VAIL REZONE AND MINOR PLAT FIRST REFERRAL REPORT

Project Name: Vail Rezone & Vail Minor Plat

Project Numbers: RZ-2026-0002 & MP-2026-0002

Project Summary: Rezone 35 acres from Agriculture (A) to (AR) Agriculture Residential and subdivide the 35 acres into 3 lots (two 10-acre lots and one 15-acre lot).

On-site System
As-Built
Drawing

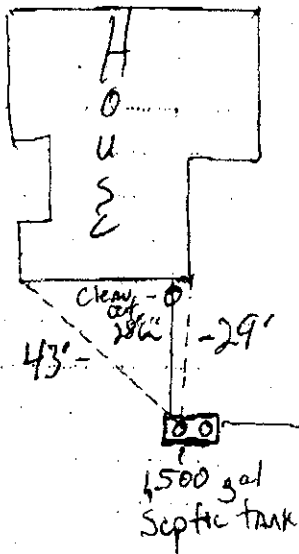
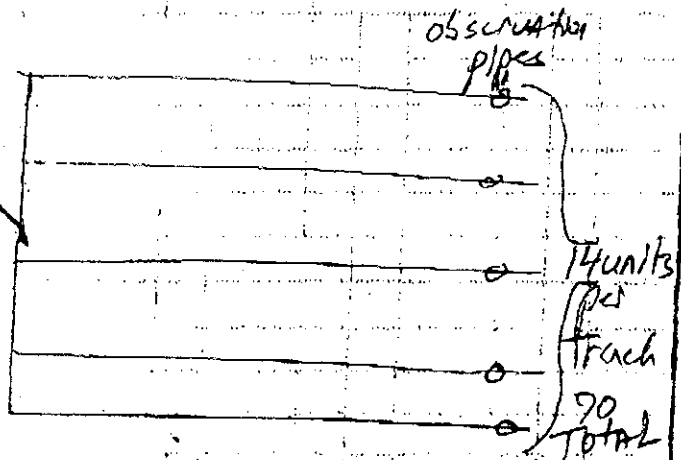
There is an existing OWTS (septic system) on the 15-acre lot. Please review the OWTS setbacks (attached) and ensure all property line setbacks will be met

--Ensure OWTS setbacks are met.
